**FINAL DRAINAGE REPORT  
FOR  
LATIGO TRAILS FILING NO. 10  
AND  
ADDENDUM TO MASTER DEVELOPMENT/  
PRELIMINARY DRAINAGE PLAN  
FOR LATIGO TRAILS,  
EL PASO COUNTY, COLORADO**

April 2022

PCD File No.: SF2136

Rating Curve Plot for Crossing: BUFFALO RIVER CROSSING

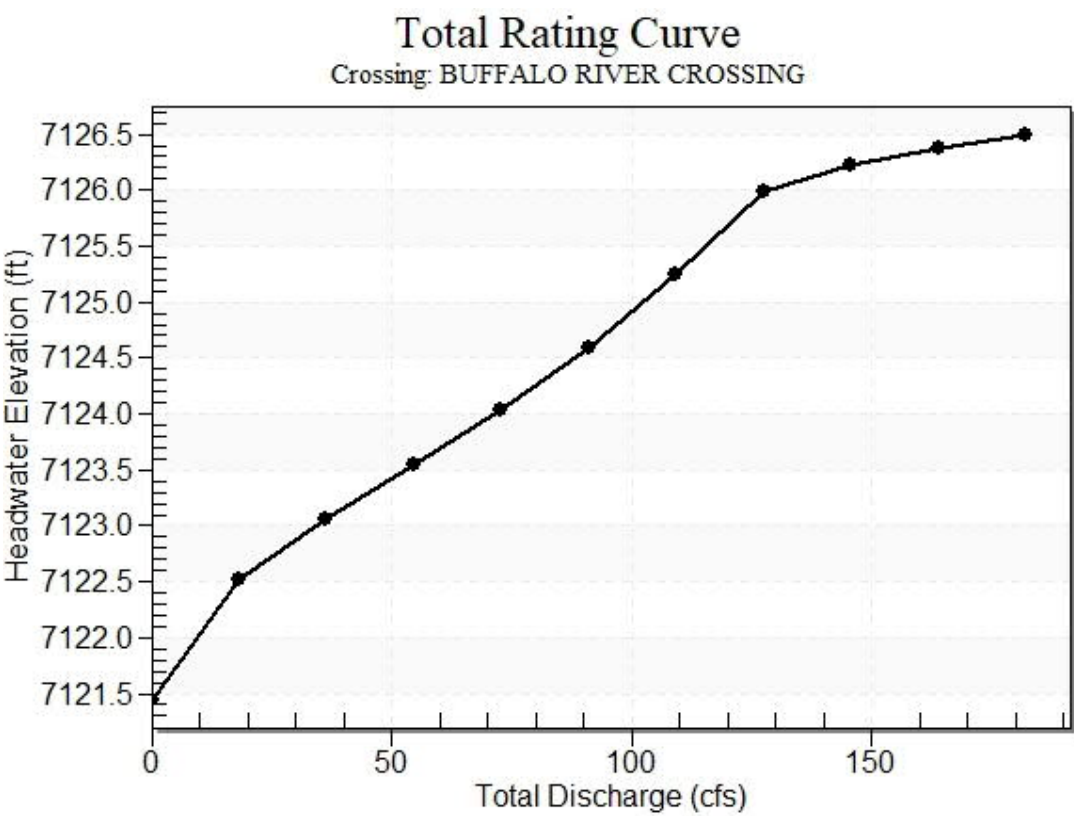
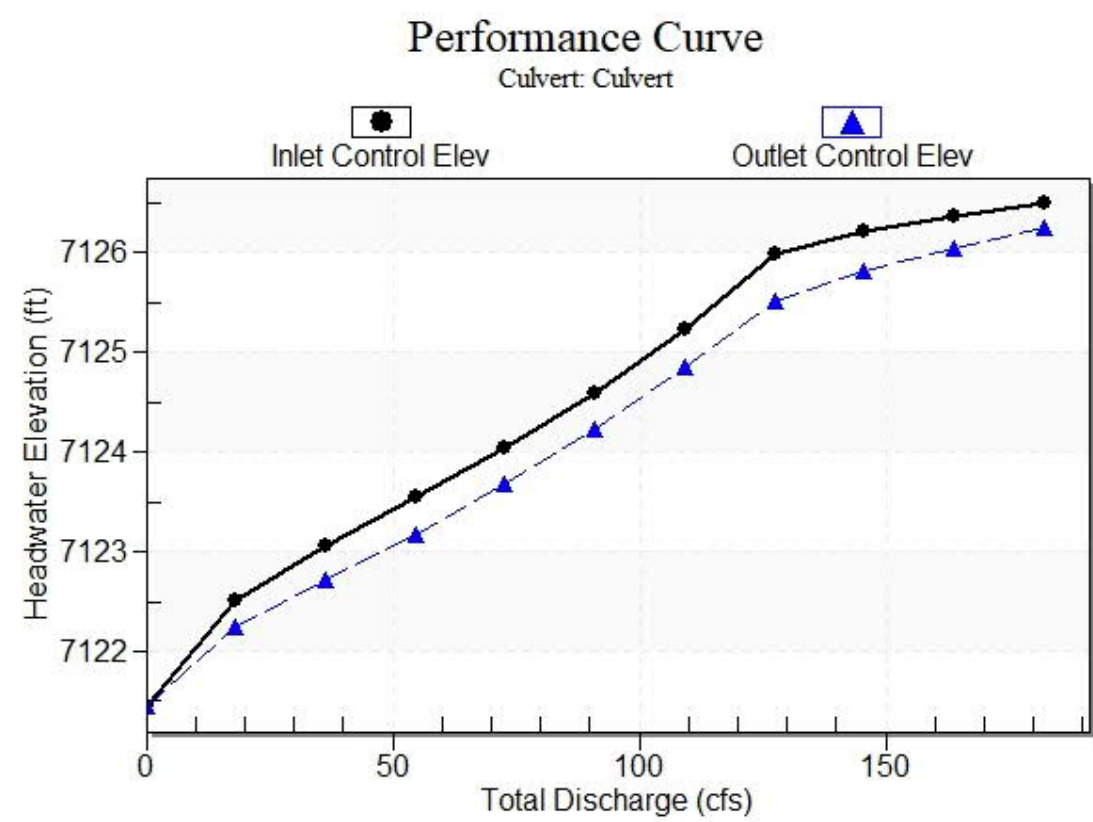
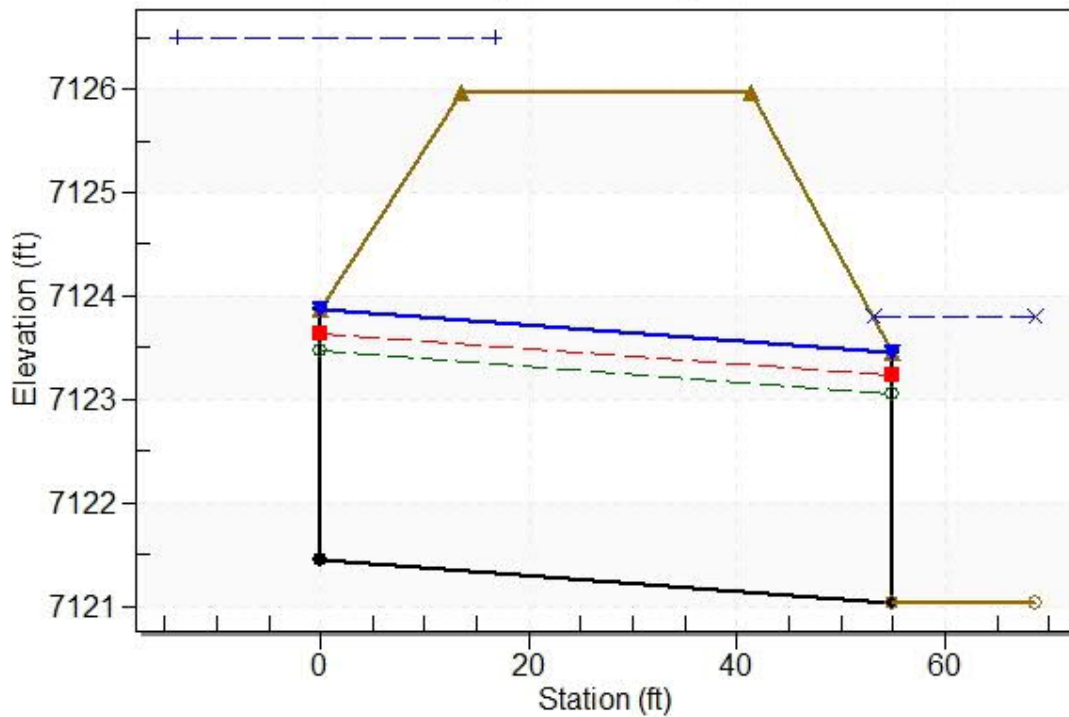
Hw/D appears to be greater than 1.5. Revise to meet criteria which is allowable Hw/D shall be less than 1.5.

Provide additional detail and explanation for the 100yr flow. The culvert analysis notes overtopping however based on the grading in the road P&P it appears runoff would be diverted to the existing 36" RCP (DP11) to the north before overtopping would occur.

If this is correct then the rational method needs to be updated to account for the flowby flow and hydraulic analysis of the existing culvert is required

PROPOSED DRAINAGE MAP  
LATIGO TRAILS FILING NO. 10  
JOB NO. 25175.02  
04/07/2022  
SHEET 1 OF 1

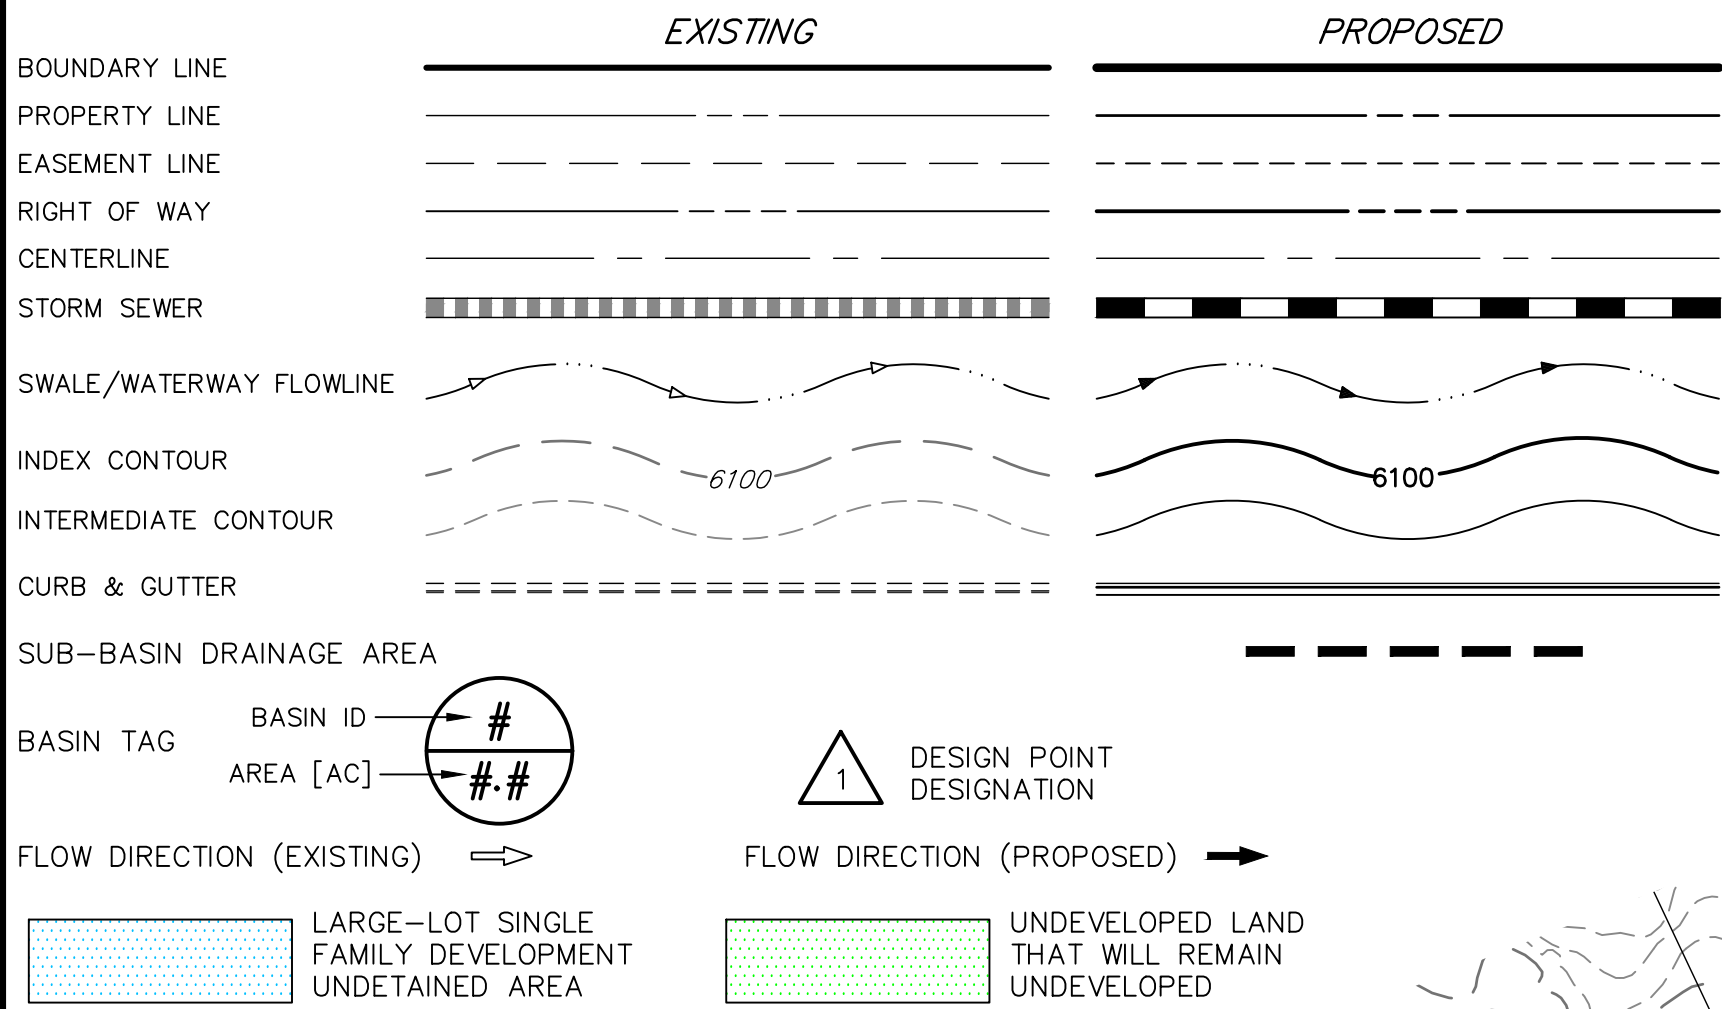
Revise the road side ditch cross sections (possibly trapezoidal) and/or depth to be able to accommodate the required driveway culverts.

This is within a lot so the undeveloped land that remains undeveloped WQ exclusion is not applicable. Revise the exclusion to the large lot or update the plat to identify this as no-build areas.

This is within a lot so the undeveloped land that remains undeveloped WQ exclusion is not applicable. Revise the exclusion to the large lot or update the plat to identify this as no-build areas.
